CWSP SYSTEM HARDENING FIELD SCOPING DOCUMENT

PM: [REDACTED]	Project Name: ECOP - SILVERADO 2104 - H05-LR726	
Notification: [REDACTED]	Region: Bay Area	City: Pope Valley
Project Manager: [REDACTED]	Division: North Bay	County: Napa

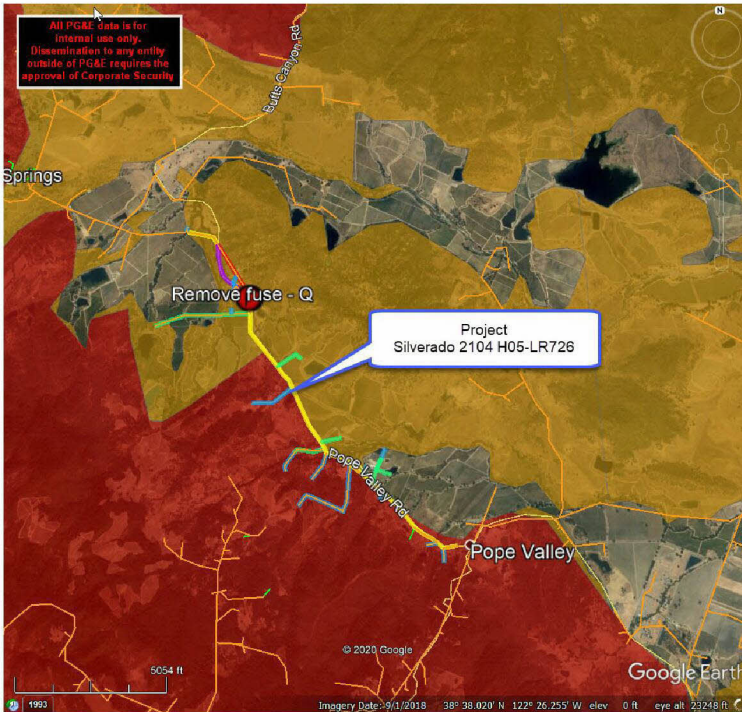
- This area has significant fire history directly impacting the project area. These fires include the Glass and LNU Complex of 2020, Kincaide Fire of 2019, County Fire 2018, Atlas, Tubbs and Nuns Fires of 2017, Rocky, Valley, and Jerusalem of 2015.

- Pope Valley Road is the main road into and out of the area for both civilians and first responders. The road needs to stay open during an emergency incident due to the loss would stop all traffic in either direction.

Fire History:

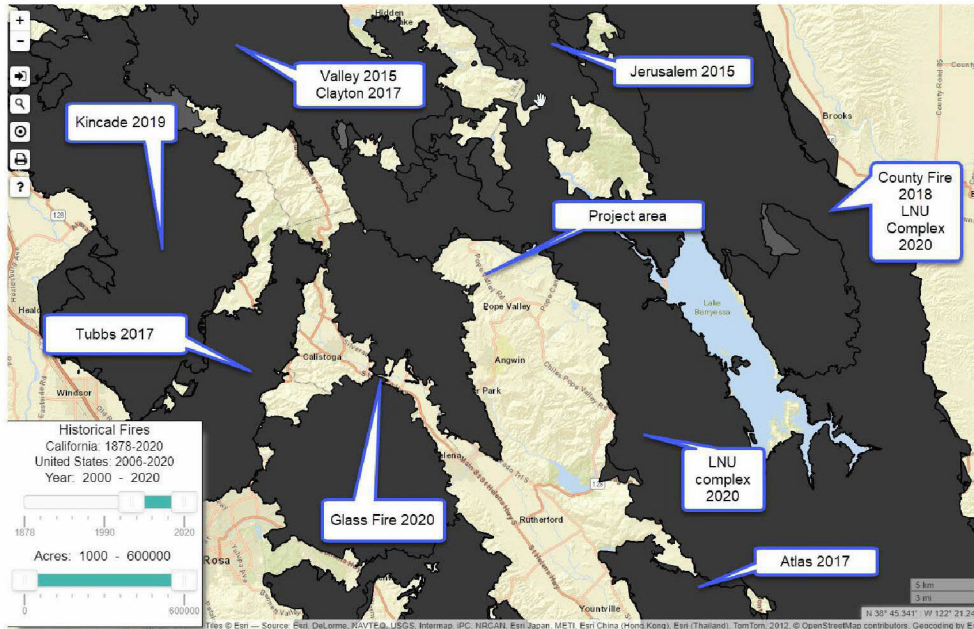
- Area of un-tiered area should remain hardened as recommended due to location of Tier 2 and Tier 3 around it.
